**7-D-22-HZ**  
**APPLICATION FOR CERTIFICATE OF APPROPRIATENESS**

214 E. Scott Ave. 37917  
 Old North Knoxville H

Original Print Date: 7/6/2022  
 Knoxville/Knox County Planning -- Historic Zoning Commission

Level II Major Repair or Replacement

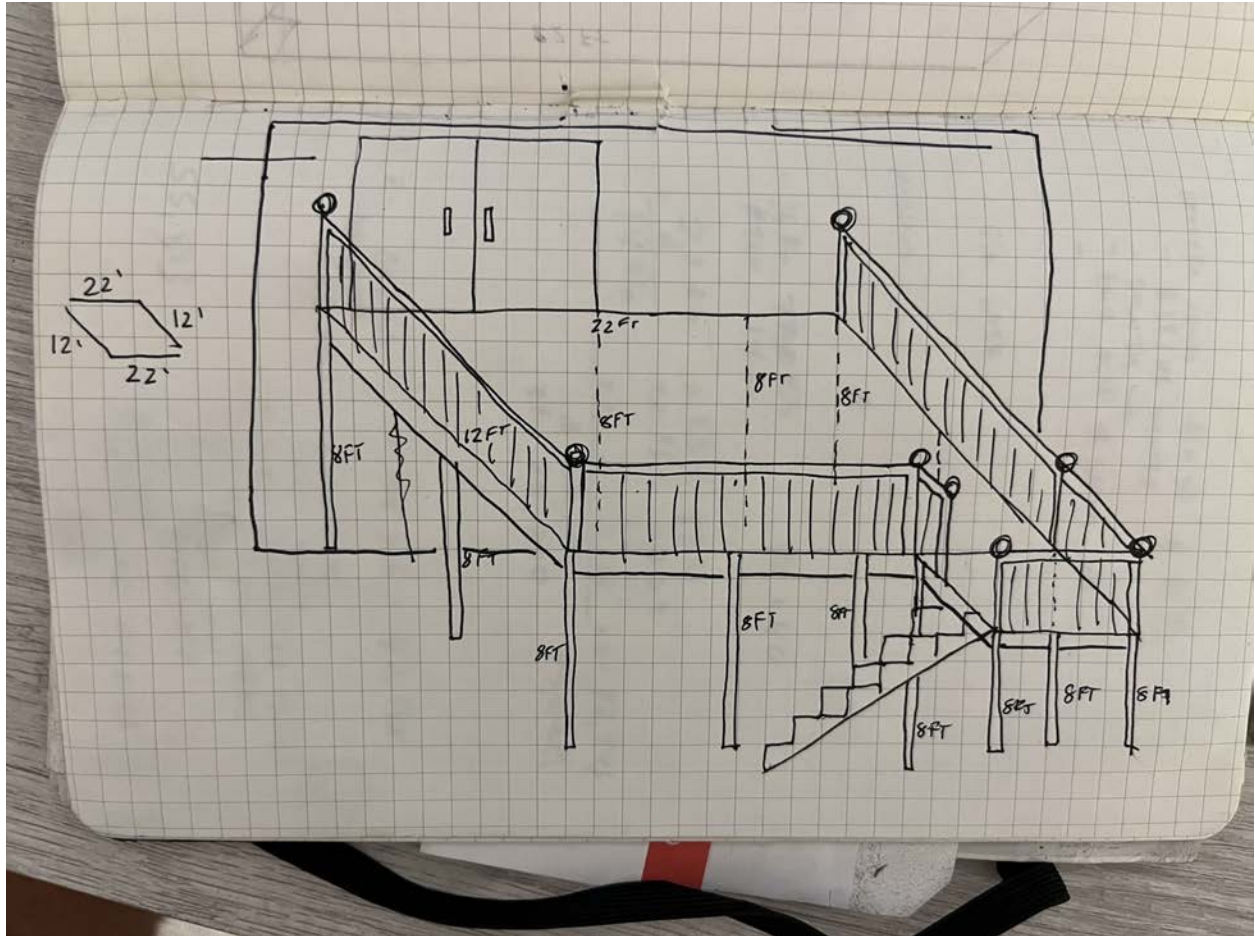
3. The rear section where windows were enclosed is a non-original rear shed-roof addition; most likely a porch which was enclosed. The windows were four adjoining six-light windows of unknown material, followed by three adjoining single-light windows of unknown material.

4. Replacing non-historic windows with wood, multi-light double doors can be appropriate on a rear elevation not visible from the primary street. The Commission may choose to discuss any additional transparency needed on the right side of the rear elevation (also enclosed with siding). A final scaled and dimensioned drawing, showing the actual doors to be installed and their placement on a rear elevation, along with any trim details, should be submitted to staff.

Staff recommends approval of the work as completed and proposed, providing for any additional rear elevation transparency or details recommended by the Commission, and subject to the following condition: 1) applicant to submit final scaled and dimensioned drawing of rear elevation work to staff for approval.

Here is the existing footprint of the home with the addition of the deck.

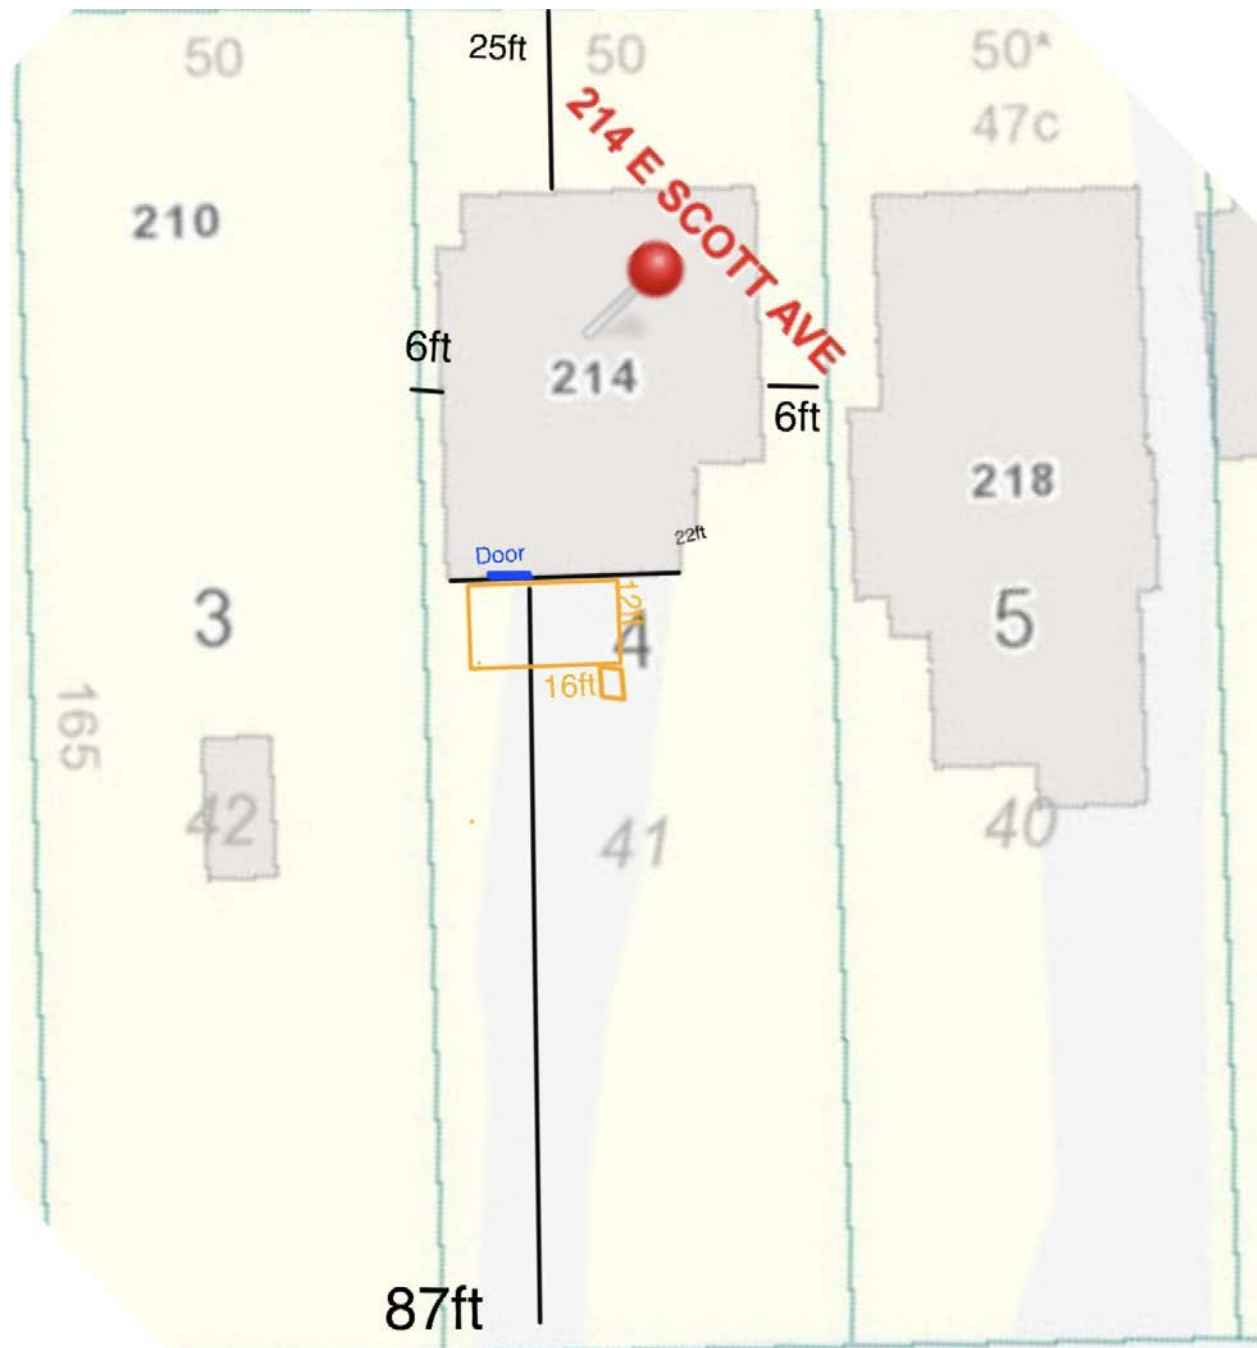
5. A rear wood deck with balusters set into the top and bottom rails meets the design guidelines.
-
